A d d e n d u m

Iowa Department of Transportation
Office of Contracts

Date of Letting: October 20, 2015
Date of Addendum: September 29, 2015

BRIDGE REPLACEMENT-PPCB
U.S. 20 WB AND EB OVER LITTLE SIOUX RIVER
0.4 MILES WEST OF IA 31

Sheet No. 1

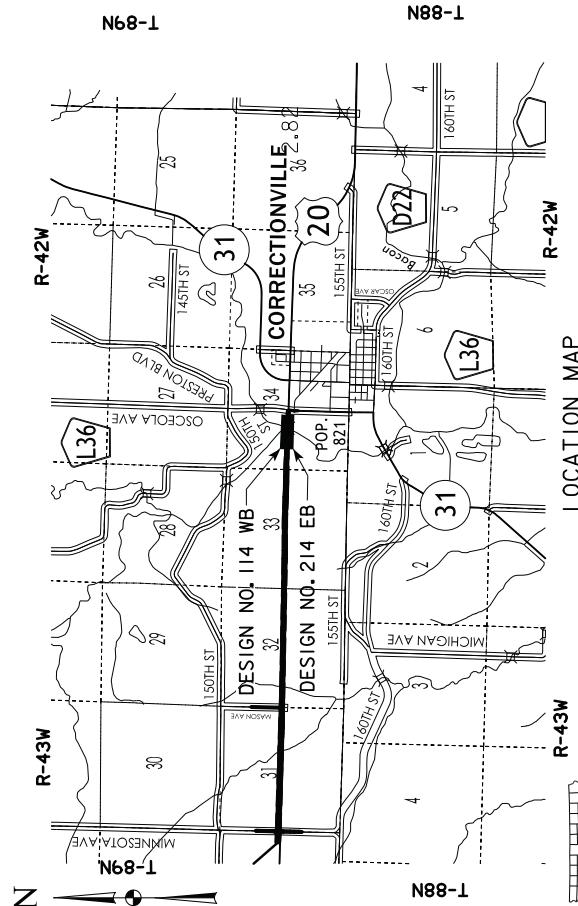
Change the reference of The Iowa Department of Transportation Standard Specifications For Highway and Bridge Construction from Series 2012 to Series 2015.

Sheet No. 4

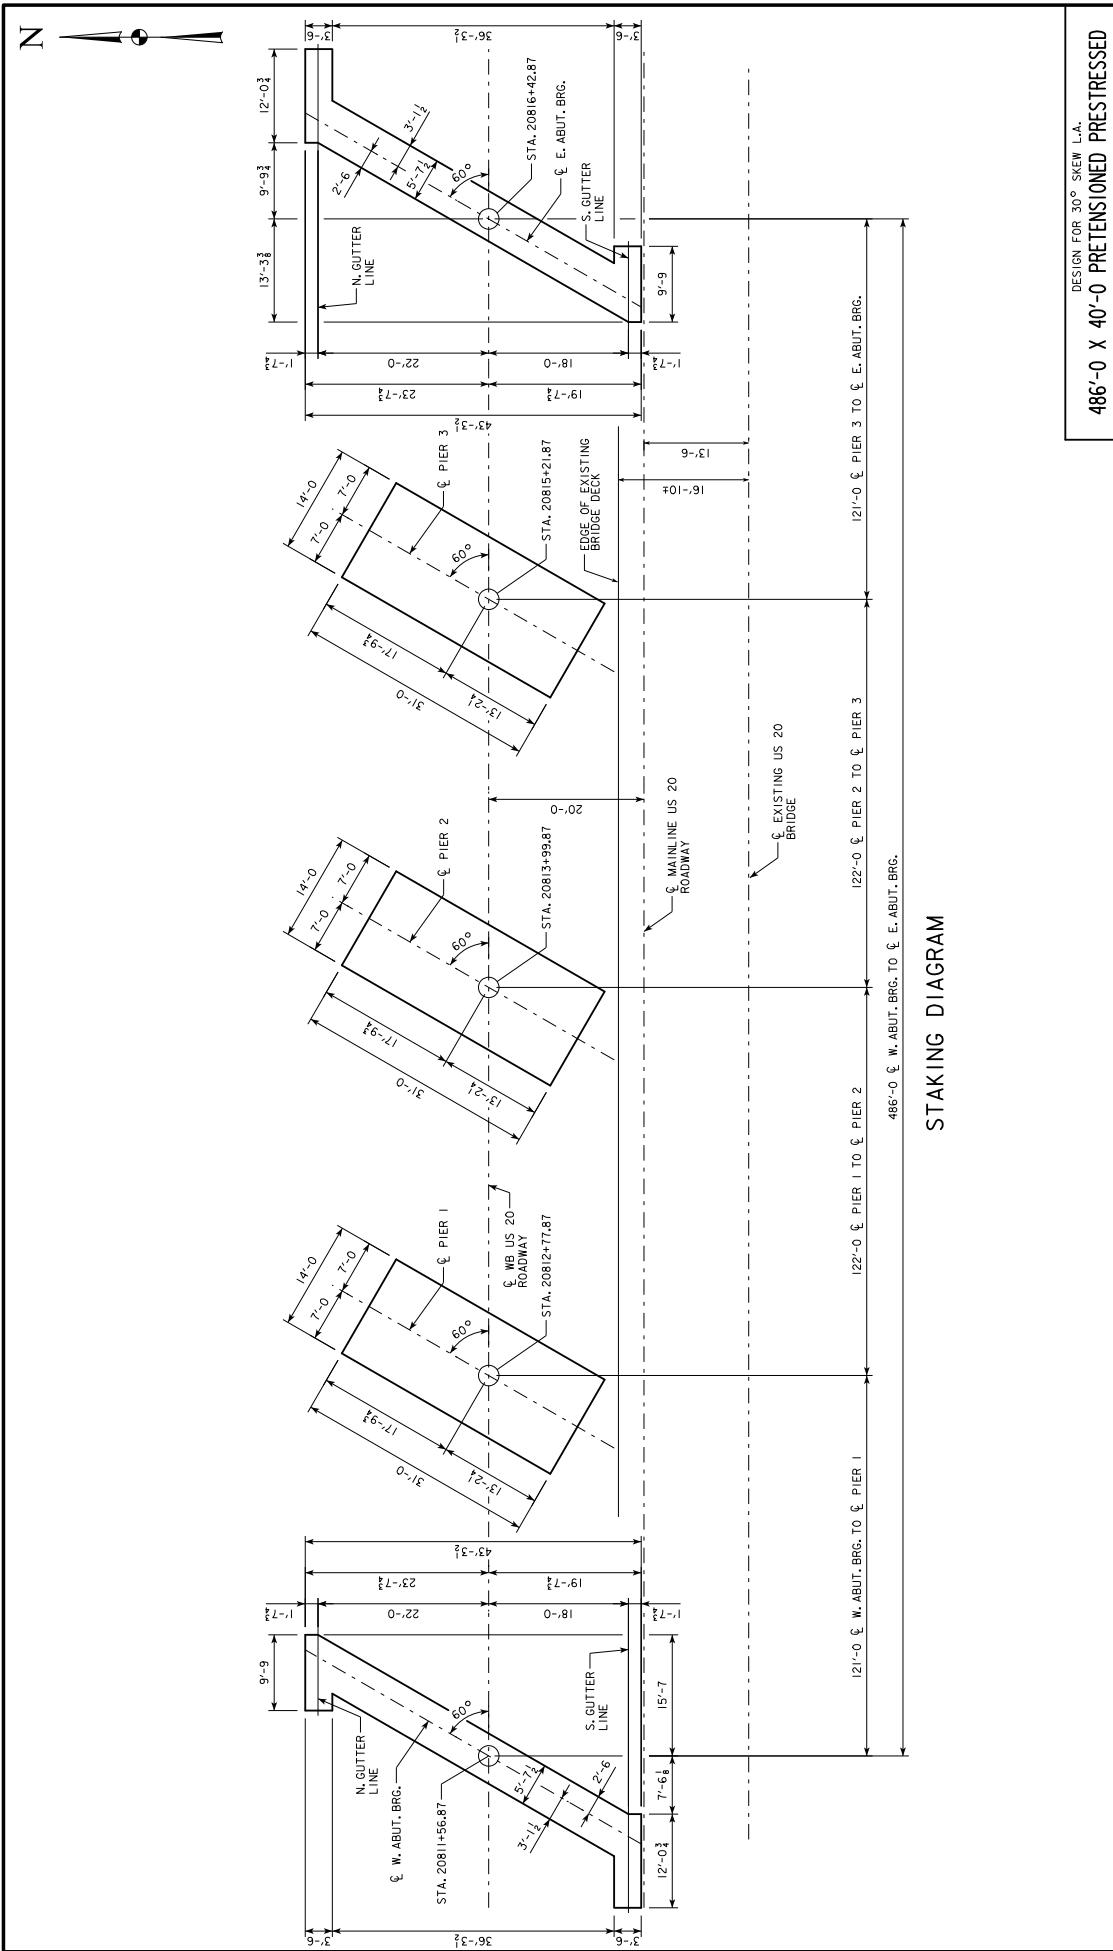
1. Under the Specifications Notes - Replace the reference of The Iowa Department of Transportation Standard Specifications For Highway and Bridge Construction from Series 2012 to Series 2015.
2. Change the Developmental Specification Number for "Developmental Specifications for Mass Concrete - Control of Heat of Hydration" from DS-12070 to DS-15032.
3. Change the Developmental Specification Number for "Developmental Specifications for High Performance Concrete for Structures" from DS-12071 to DS-15033.

Sheet No. 40

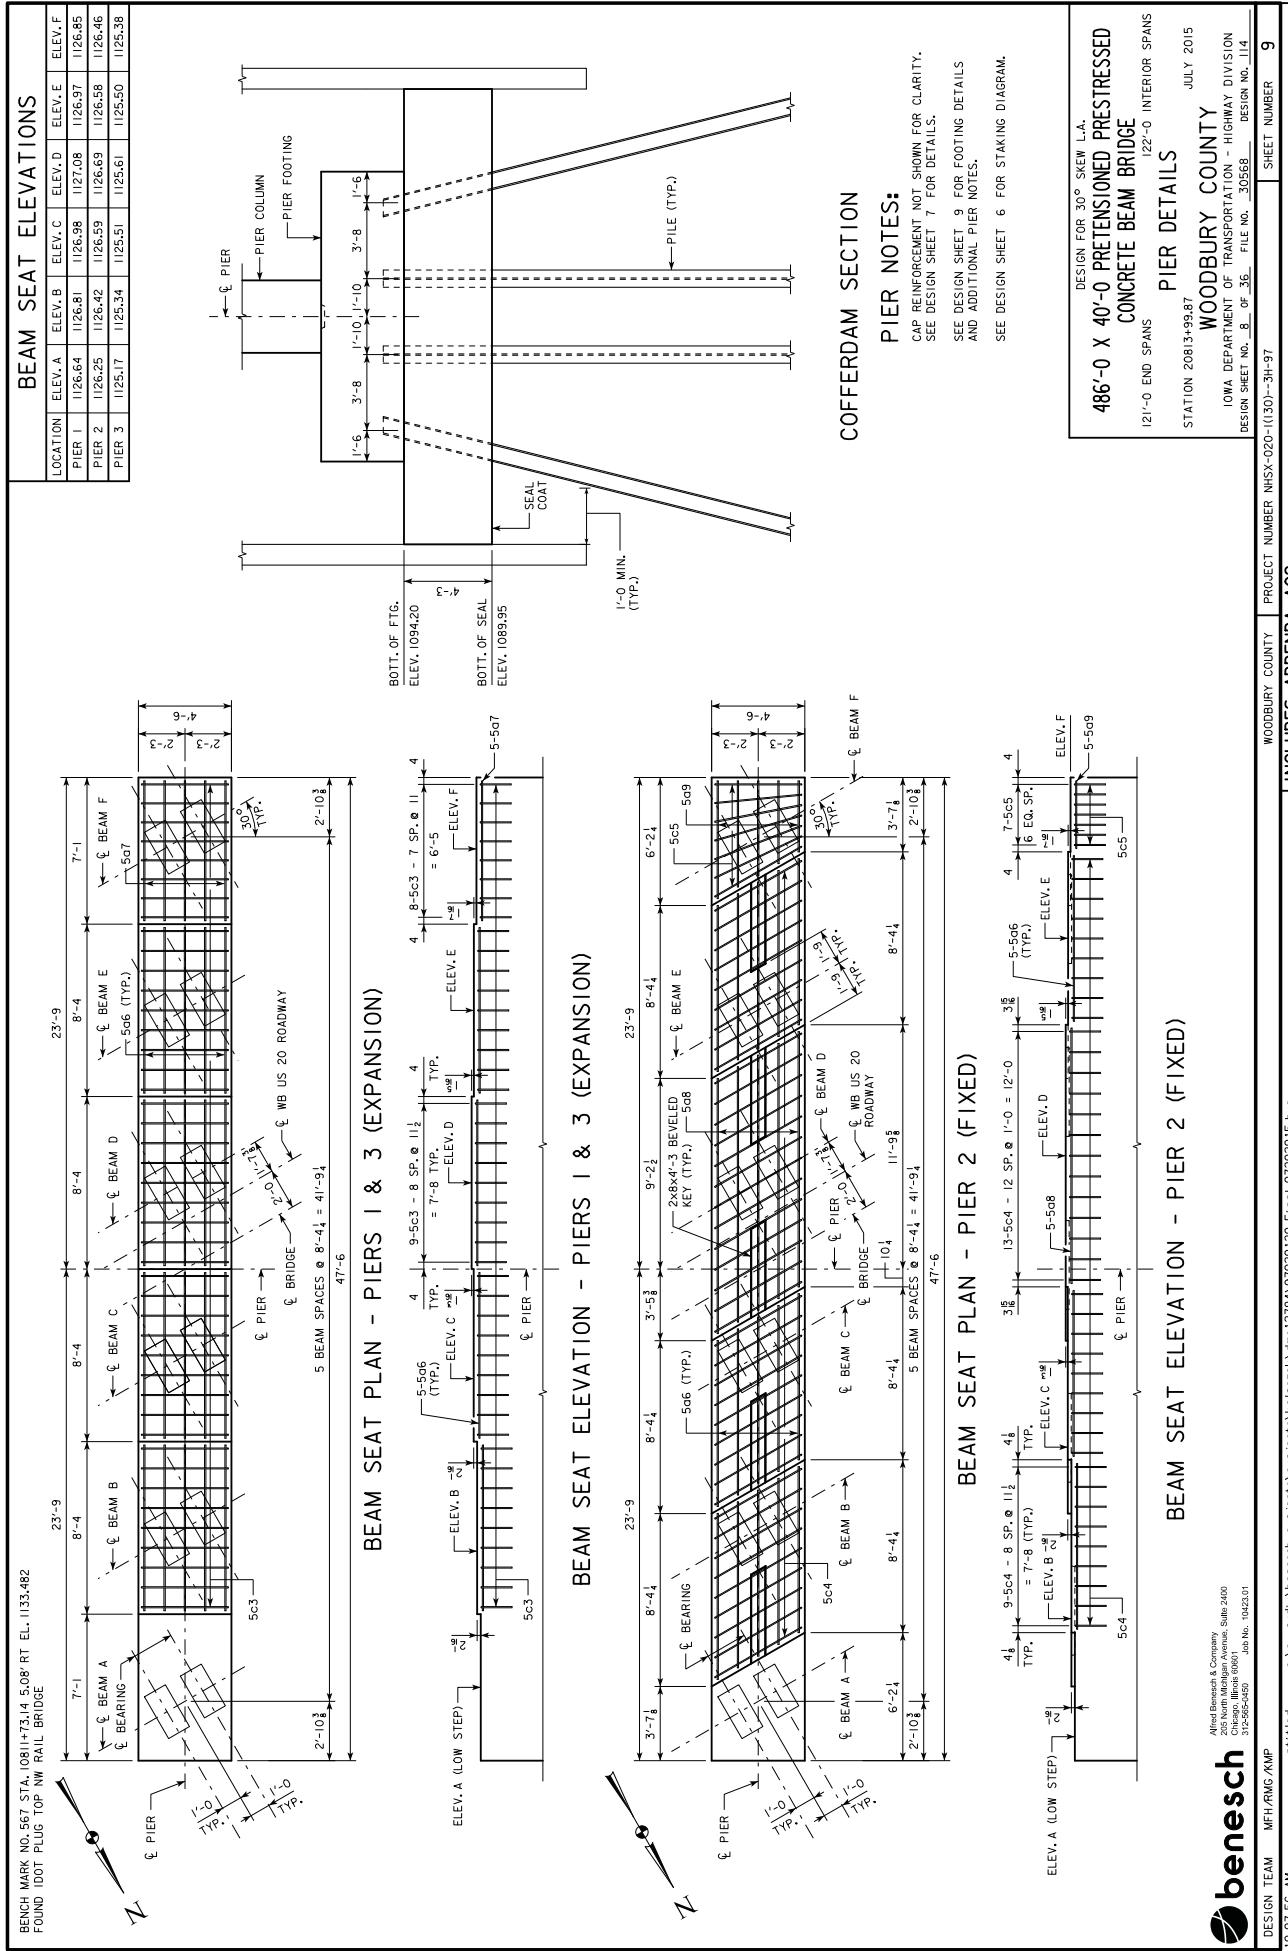
1. Under the Specifications Notes - Replace the reference of The Iowa Department of Transportation Standard Specifications For Highway and Bridge Construction from Series 2012 to Series 2015.
2. Change the Developmental Specification Number for "Developmental Specifications for Mass Concrete - Control of Heat of Hydration" from DS-12070 to DS-15032.
3. Change the Developmental Specification Number for "Developmental Specifications for High Performance Concrete for Structures" from DS-12071 to DS-15033.
